SUBJECT: PORE SIZE OF FILTERS USED DURING TESTING OF DIESEL GENERATOR FUEL OIL (TAC NO. 71888)

RE: LIMERICK GENERATING STATION, UNIT 1

Amendment No. 21  
License No. NPF-39

SAFETY EVALUATION BY THE OFFICE OF NUCLEAR REACTOR REGULATION

DIESEL FUEL OIL FILTRATION CONFIGURATION  
FIGURE 1

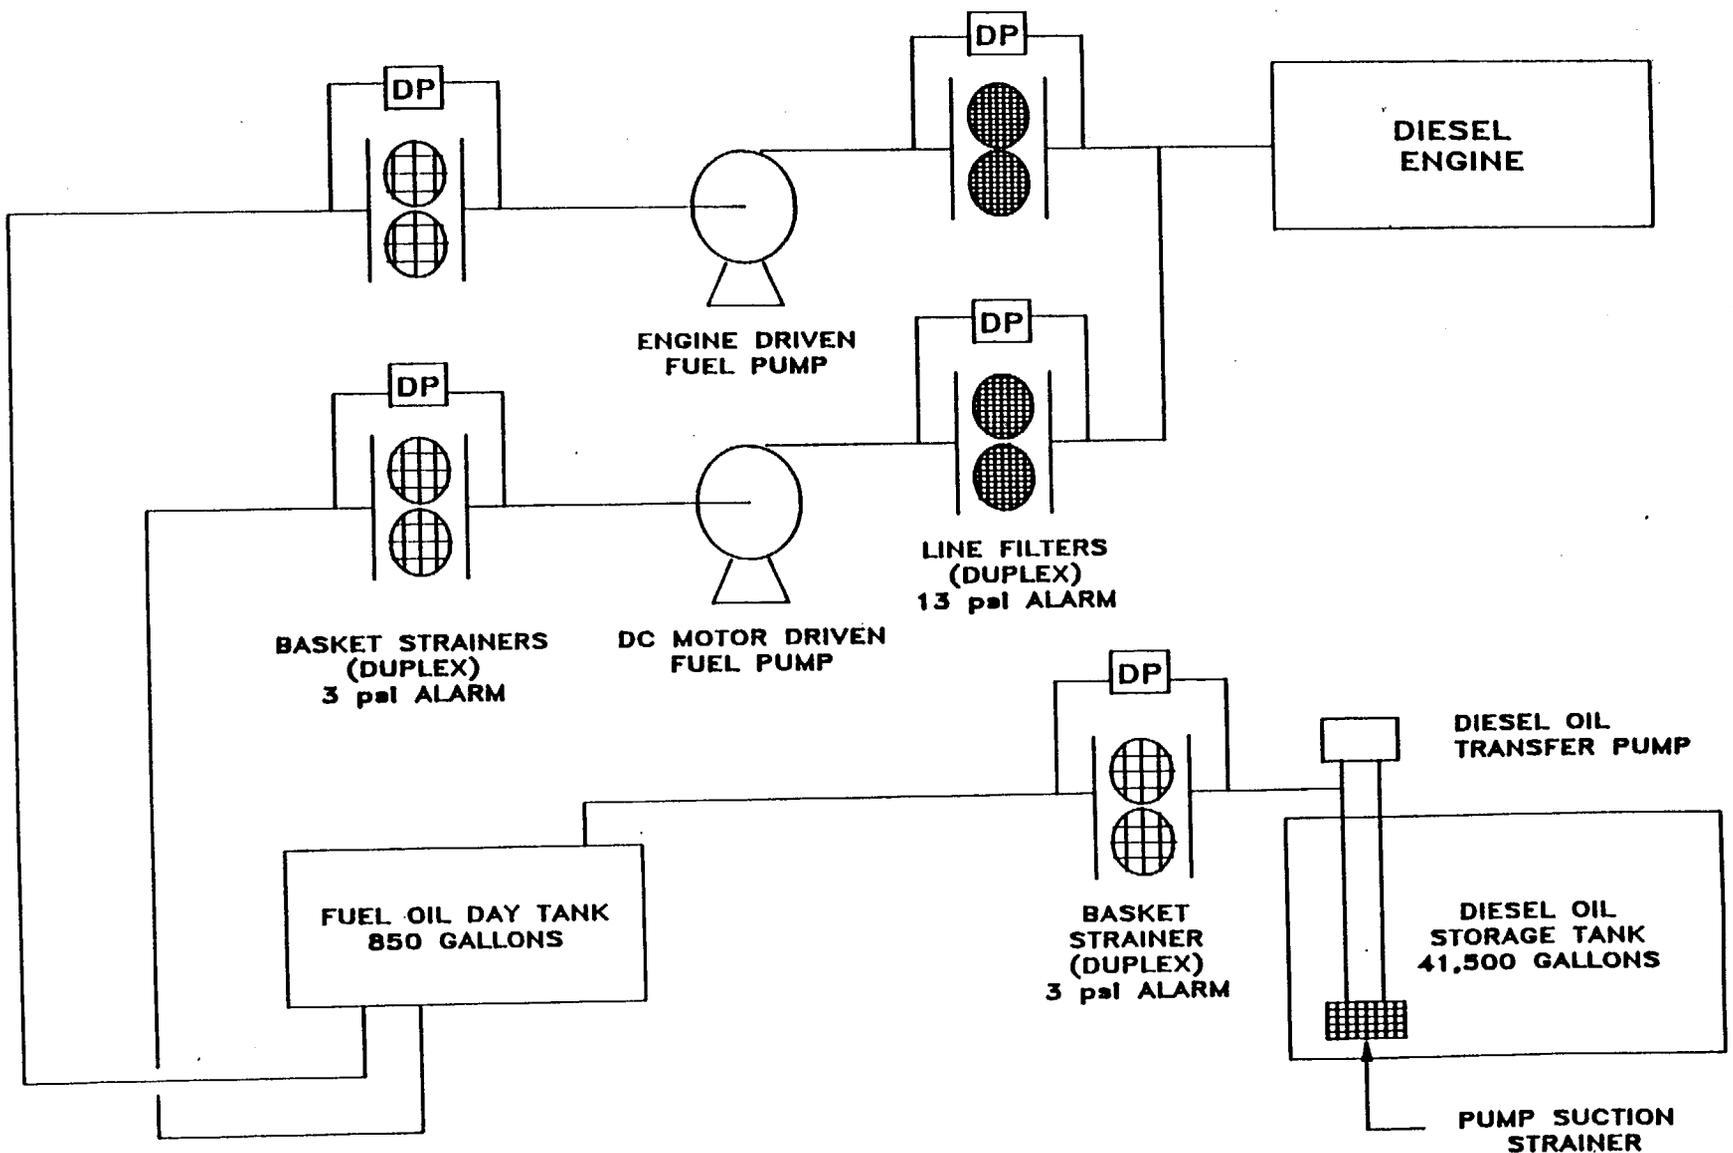
The Limerick plant has eight emergency diesel generators (EDGs) for the two units. The EDG fuel oil system is a safety-related system which provides on-site storage and delivery of EDG fuel oil for at least seven days of continuous operation of all EDGs operating at their full-rated load. Each EDG is provided with an independent fuel oil system. Each fuel oil system provides fuel oil to diesel engine fuel injectors and consists of a fuel oil storage tank, a fuel oil transfer pump, a day tank, an engine-driven fuel pump, a dc motor-driven auxiliary fuel pump, and associated piping, valves, strainers, filters and instrumentation (See Figure 1).

2. The fuel oil transfer pumps are equipped with a suction strainer to prevent the entrance of any large particles or debris.
3. Any particulates passing through the fuel oil transfer pump would be trapped by the strainers and filters located between the fuel oil transfer pump discharge and the diesel engine. Basket strainers are located on the fuel oil day tank supply piping and one on the suction of both the engine-driven fuel oil pump and the dc motor-driven fuel oil pump.

4. These filters and strainers are equipped with differential pressure indicators and alarms to notify the operators of impending clogging. The basket strainers will alarm when the pressure differential exceeds 3 psid. Due to the higher pressure drop present for fine fuel oil filtration in the line filters, the alarms on these filters will sound when the pressure drop exceeds 13 psid. Operating history of the line filters has resulted in the observation that a rise in the differential pressure across the filters from 1 psi to 4 psi occurs during an 18-month reactor fuel cycle at LGS. This 18-month cycle includes a monthly EDG run for surveillance testing and numerous other EDG runs for various reasons. Operating history of the strainers indicates a negligible rise in differential pressure during an 18-month reactor fuel cycle. These alarm settings provide ample time for the operator to manually switch to the other filter or strainer element before the operability of the EDG is compromised.
